Apparel Today Ltd. New

23 September 2019

Observations

16 rebar shown in C1A Column

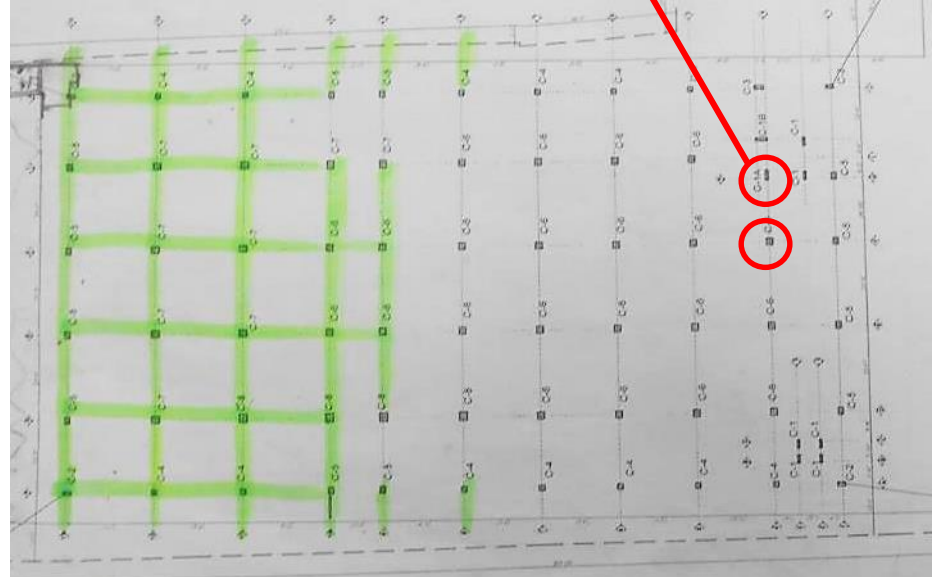
14 rebar observed in C1A column at grid G-4

14 number of rebar was found in C1A column at grid G-4 where 16 rebar has been shown in the structural drawings. Also, in C6 column at grid F-4 rebar diameter was measured 25mm for 5 rebars instead of 12 rebars.

Future extension of existing building

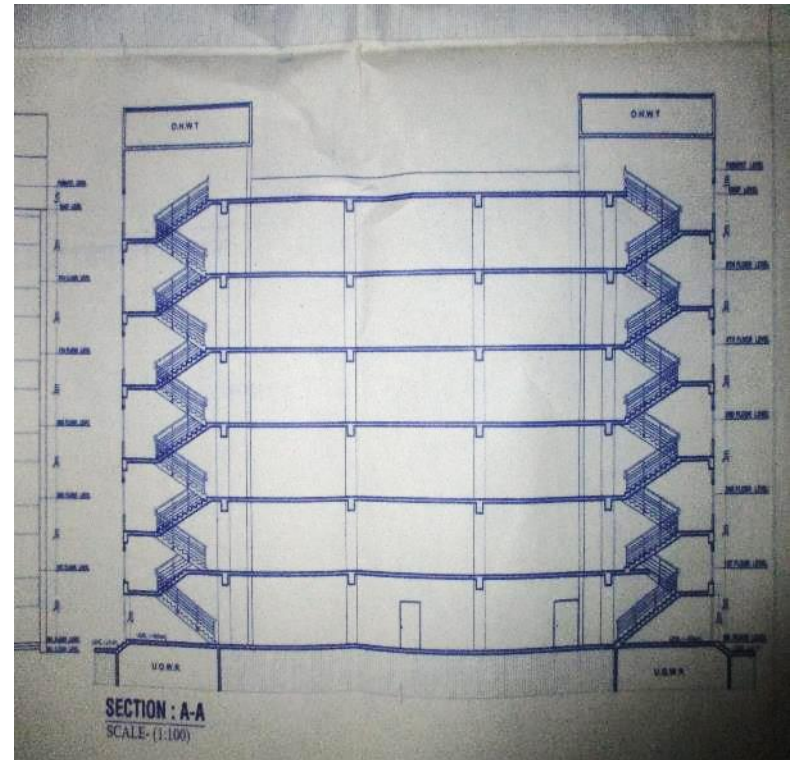
Factory has permit drawings for 6 Storey factory building. Factory has a plan to extend the building vertically up to 6-Storey. The column capacity has been checked for existing condition (3-Storey).

Exposed rebar indicates possibility of vertical extension in future.

For any vertical extension, columns may have higher stresses. A Detail Engineering Assessment (DEA) considering BNBC provision to be completed prior commencement of further construction.
